**ZONING AMENDMENT STAFF REPORT****Date: March 5, 2015****NAME**

Robert Brown

**LOCATION**7054 Howells Ferry Road  
(Northeast corner of Howells Ferry Road and Cody Road).**CITY COUNCIL  
DISTRICT**

Rezoning from B-2, Neighborhood Business District and R-1, Single-Family Residential District, to B-2, Neighborhood Business District, to allow a banquet hall.

# SITE PLAN

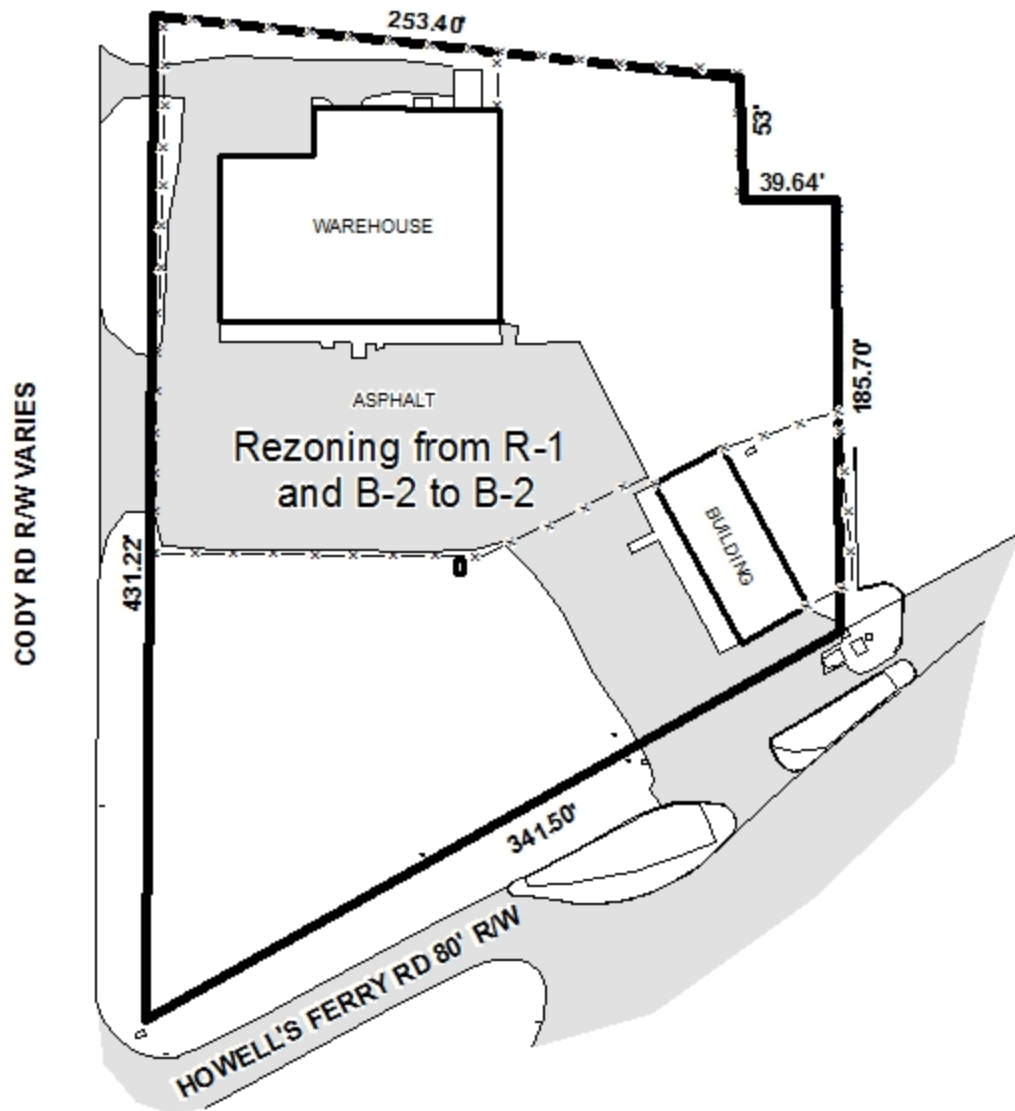
*The preliminary plat submitted provides the lot size in acres and should be revised to include square feet as well. It should be noted that the proposed lot exceeds the minimum required lot size in Section V.D.2. of the Subdivision Regulations.*

*The 25-foot minimum building setback is not illustrated on the preliminary plat. If approved, the setback should be adjusted for dedication on the Final Plat.*

*The site has frontages along Howells Ferry Road and Cody Road, both major roads, which should have a minimum right-of-way of 100'. The preliminary plat illustrates Howell's Ferry Road with an 80' right-of-way, and Cody Road with a right-of-way that varies. Dedication to provide a minimum of 50' from the centerline should be made along both streets. Furthermore, dedication of the corner radii at Cody Road and Howells Ferry Road per Section V.D.6. of the Subdivision Regulations should be required. As a means of access management, the site should be limited to the existing curb cuts.*

- 1) dedication to provide 50' from the centerline of Howells Ferry Road;
- 2) dedication to provide 50' from the centerline of Cody Road;
- 3) dedication of the corner radii at Cody Road and Howells Ferry per Section V.D.6. of the Subdivision Regulations;

- 4) illustration of the 25' minimum building setback line along all frontages, adjusted for dedication;
- 5) provision of the lot size in square feet and acres, adjusted for dedication;

# SITE PLAN

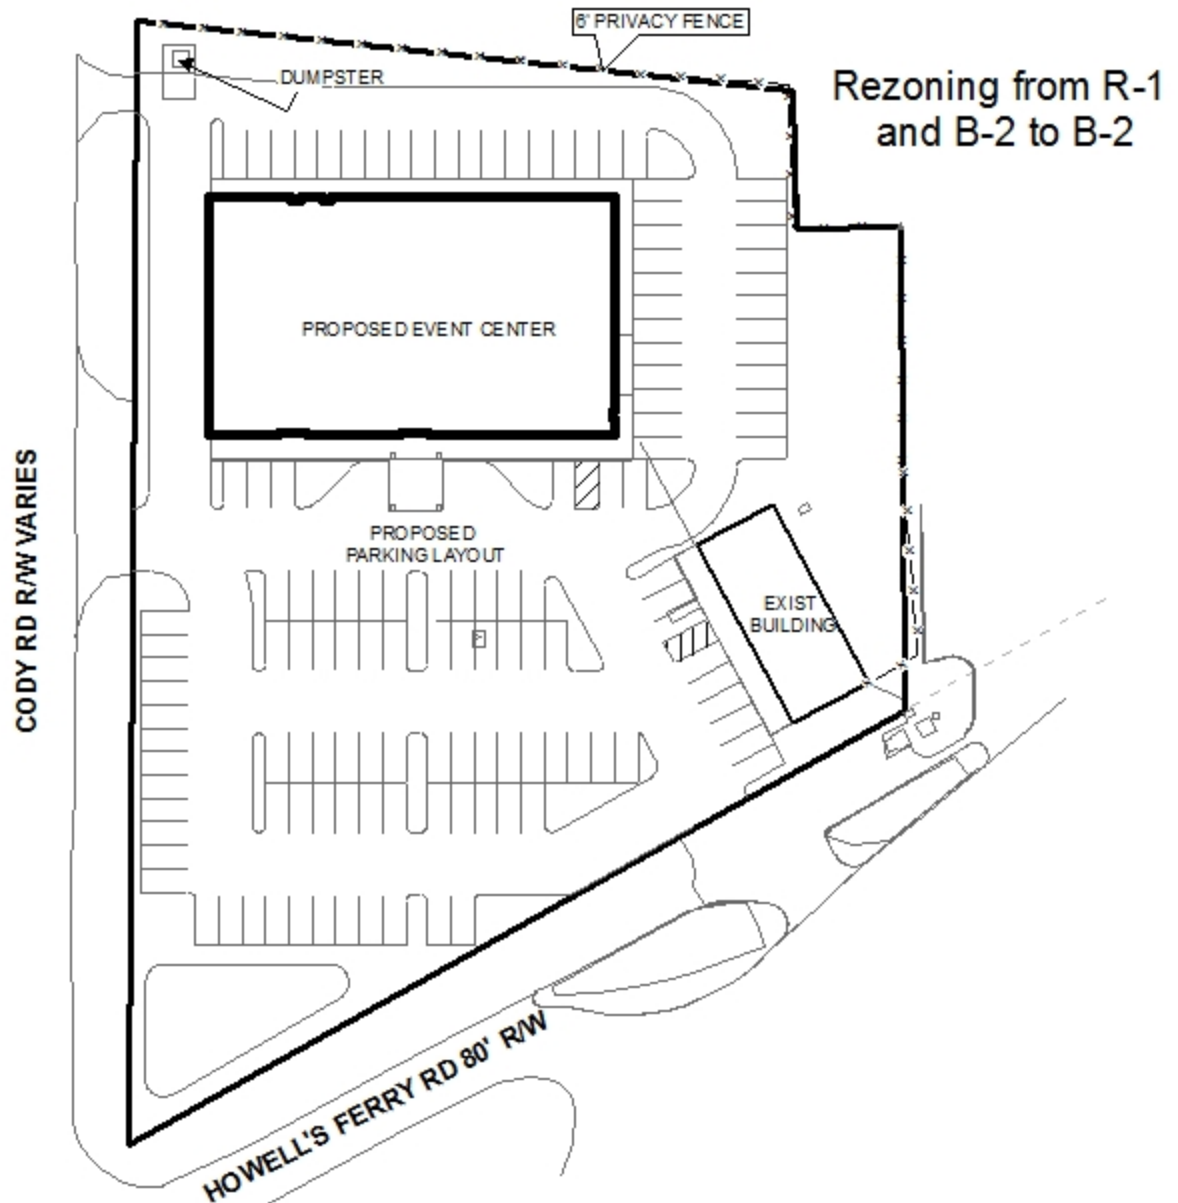
The submitted site plan does not provide any information on the amount of parking to be provided on the site, nor is any landscaping and tree planting information provided. The site plan should also be revised to illustrate any existing or proposed dumpster with compliant enclosures such as required by Section 64-4.D.9. of the Zoning Ordinance, or state that curbside pickup will be used.

A fence is illustrated around a portion of the site, with no mention of the height or materials. The property located along the rear property line of the subject site is residential in nature, therefore the site plan should be revised to illustrate a residential buffer compliant with Section 64-4.D.1. of the Zoning Ordinance.

*The submitted site plan illustrates the existing office building to remain on site is 2,548 square feet, and the proposed event building will have 480 seats, meaning the site will be required to have 129 parking spaces (1/300 & 1/4 seats), which are illustrated on the site. Bumper stops or curbing should be provided for all parking spaces, and the site will have to comply with the parking lot lighting requirements of Section 64-6.A.8. of the Zoning Ordinance. It should be noted that because there is no parking on site above the minimum required number, a restaurant cannot be allowed to occupy any part of the existing office building, nor will the event hall be able to expand its occupancy without additional parking provided on the site.*

*A dumpster with a compliant enclosure is illustrated behind the proposed event center; however it is unclear if the dumpster will serve both buildings on site. If a separate dumpster or curbside pickup will be used for the office building, it should be noted on the site plan with all dumpsters enclosed per Section 64-4.D.9. of the Zoning Ordinance.*

*A 6' high privacy fence is illustrated along the North and East property lines to provide a residential buffer as required by Section 64-4.D.1. of the Zoning Ordinance. It should be noted that the privacy fence cannot exceed 3' high within the 25' front minimum building setback line.*

*The revised site plan includes landscape area and tree planting calculations. Based upon the calculations provided, there will be sufficient landscape areas, however it appears that a slight*

calculation error was made regarding parking trees, where the applicant states that 6 trees will be required when actually 7 trees should be provided, making for a total of 49 trees to be provided (34 overstory trees and 15 understory trees).

There is a note on the submitted site plan stating that “a sidewalk waiver is requested”. It should be noted that a separate Sidewalk Waiver application with the accompanying required documentation must be submitted to the Planning Commission in order to waive the sidewalk requirement.

- 1) revision of the site plan to include bumper stops or curbing for all parking spaces;*
- 2) placement of a note on the site plan stating the site will be in compliance with parking lot lighting requirements of Section 64-6.A.8. of the Zoning Ordinance;*

- 3) placement of a note on the site plan stating that no restaurants will be allowed on site, nor will the event hall increase capacity without the provision of additional parking spaces, which will require a new PUD application;*

- 4) revision of the site plan to either state the office building will use curb-side pickup or will utilize a separate dumpster on site with an enclosure compliant with Section 64-4.D.9. of the Zoning Ordinance;*

- 5) revision of the site plan to illustrate that the privacy fence along the North and East property lines will not exceed 3' high within the 25' setback;*

- 6) revision of the site plan to indicate that 49 trees (34 overstory trees and 15 understory trees) will be provided on the site;*
- 7) revision of the site plan to show installation of a sidewalk or obtain a sidewalk waiver;*
